**UNITED STATES ENVIRONMENTAL
PROTECTION AGENCY
REGION IX**
75 Hawthorne Street
San Francisco, CA 94105

**STATE OF HAWAII
DEPARTMENT OF HEALTH**
P. O. BOX 3378
HONOLULU, HI 96801-3378

SUBJECT: Groundwater Monitoring Well Network – Installation of Additional Wells

Re: Comments on Figure “Proposed and Existing Monitoring Well Locations Red Hill Bulk Fuel Storage Facility JBPHH, O’ahu, Hawai’i” and Accompanying Microsoft EXCEL File “Approximate Coordinates for Proposed Wells_20220111.xlsx”

Figure 1 – Schematic Illustration of “Plume Diving”, which is Most Applicable to Dissolved Phase Contamination with Increasing Distance from Source Areas

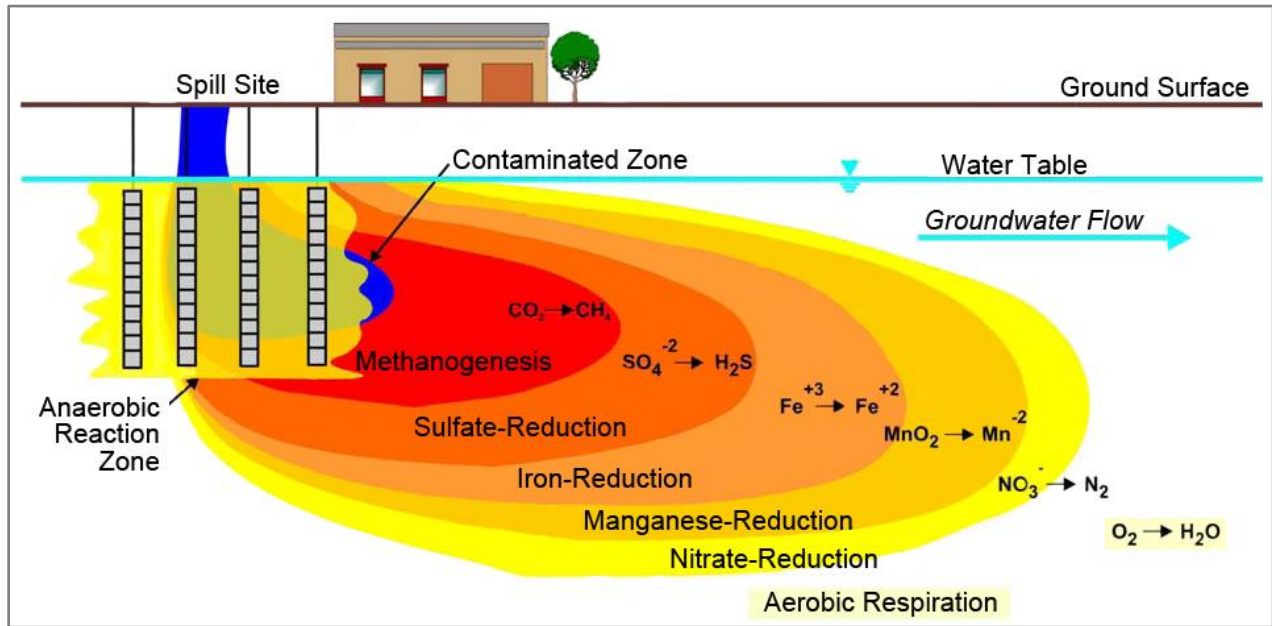
In addition, it is likely that standard well completions may not be adequate for purposes of further characterization. With the exception of the WestBay systems, standard well installations at the site are typically screened across or close to the water table. This form of well completion is typically suitable below or close to locations where Light Non-Aqueous Phase Liquid (LNAPL) has been released and migration distances are small, because it provides opportunity to measure for sheen on the water table and also obtain samples from below the sheen if one is present, thereby providing information regarding dissolved phase concentrations. However, this construction becomes less suitable with increasing distance from releases, as contamination can be present deeper below the water table as a result of “plume diving” (**Figure 1**). While noting that plume diving can result from several causes, and that the current evidence for plume diving in and around RHBSF is fairly limited, this lack of evidence results at least in part from a relative lack of deeper-screened intervals at increasing distance from RHBSF. Consequently, we cannot be certain that water table screen completions are suitable moving away at greater distance from release locations (i.e., RHBSF and RHS) toward other potential receptors such as the BWS Halawa shaft, and the Aiea Halawa Shaft (Navy). For this reason, it is recommended that characterization borings be drilled prior to selecting well screen interval(s) at increasing distance from actual and potential sources toward these potential receptors.

Given the foregoing, alternative well construction approaches and designs should be considered, particularly for locations further from releases, preferably nested borings – not Westbay units in this particular instance but rather dual-completions with one screen located at the water table and one screen located at the next encountered transmissive interval. Alternatively, consideration could be given to long-screen completions straddling water table (for LNAPL identification) and enabling snap-samplers or other related methods for saturated zone sampling. It is noted that the longer-screen completion is a less satisfactory option as it may result in ambiguity in the interpretation of sample results. Furthermore, downhole geophysics, hydraulic, and water quality, testing should be considered before well construction is finalized at these locations. This is particularly critical for the lower (i.e., higher depth) interval within a nested (paired) boring construction, to ensure that the screen is completed within a hydraulically connected formation. If it is not technically feasible to conduct testing during drilling to identify the most suitable screen interval for the lower of the two screens (assuming a dual screen completion design), then the default design should comprise an upper screen straddling the water table, and a lower screen that intercepts the next encountered plausibly transmissive material.

Figure 2 – Depiction of Alternate Proposed Locations for New Near-Field Monitoring Wells (Blue Dots) and Proposed Locations for New Sentinel Monitoring Wells (Green Dots)

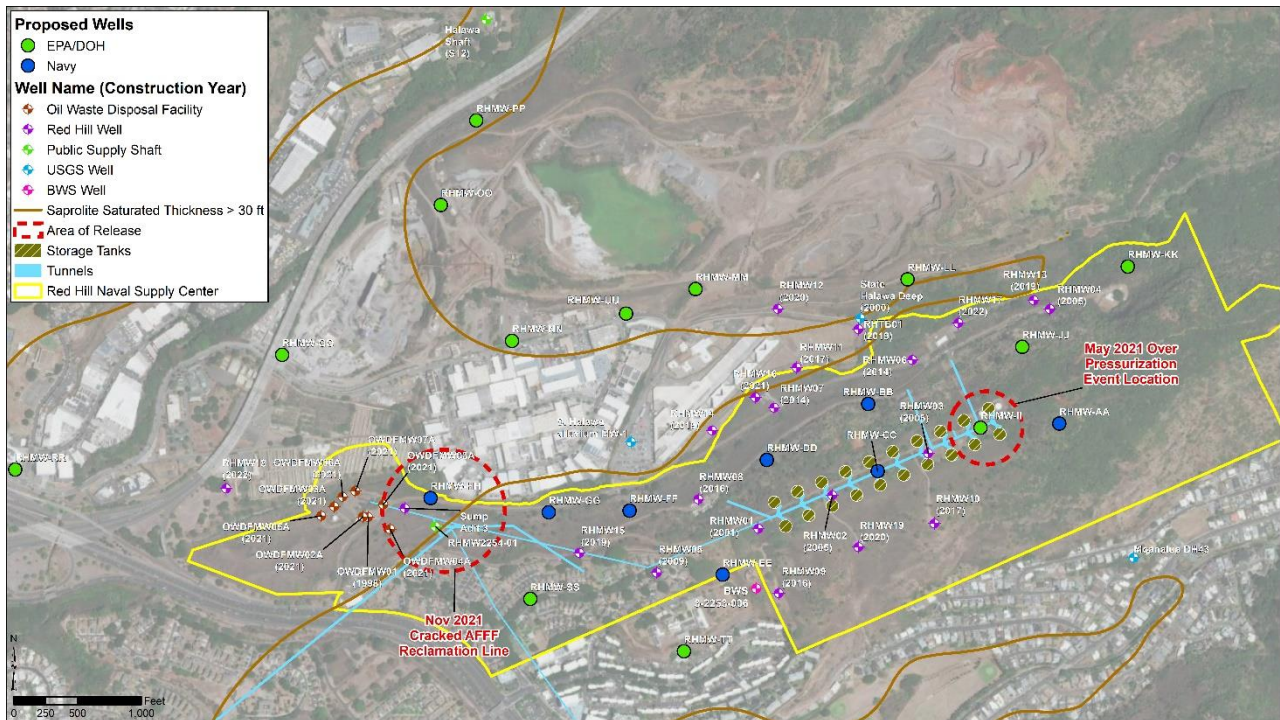
Given the foregoing general comments and recommendations, the following are specific comments on the geographic locations of the monitoring wells proposed by the Navy (i.e., RHMW-AA to -HH). A figure is also provided identifying these re-locations as blue dots (**Figure 2**):

- RHMW-AA – move to SE provide coverage with additional well (discussed below)

- RHMW-BB – move a little closer into previous mapped footprint of likely groundwater impact
- RHMW-CC – this location could be considered a lower priority for installation at a later date
- RHMW-DD – consider moving this location further to W for more even spatial coverage
- RHMW-EE – move a little more to SE for even split of RHMW-05 and -09
- RHMW-FF – bring to S unless goal is to tag saprolite. Otherwise, there may be an improve chance of identifying the clinker in this area that intercepts the east end of RHS
- RHMW-GG – small move to S side of road
- RHMW-HH – if possible, recommend awaiting piezometer findings before finalizing this location

In addition to proximal monitoring, sentinel monitoring is strongly recommended at locations further beyond the RHBSF and RHS, in the general direction of other potential receptors such as the BWS Halawa shaft, and the Aiea Halawa Shaft (Navy). In particular, sentinel monitoring for potential migration toward BWS Halawa shaft is considered the highest priority and should proceed once access and permitting requirements and agreements have been met. A series of proposed locations is depicted as green dots in **Figure 2**. These locations are selected to provide sentinel monitoring of any potential migration toward the BWS Halawa shaft (together with other attendant data and information such as water levels, stratigraphy, etc.) via both an “upper” (western) potential migration route and a “lower” (eastern) potential migration route. Some of these locations coincides in a broad sense with locations proposed on this, or prior, occasions by the Navy.
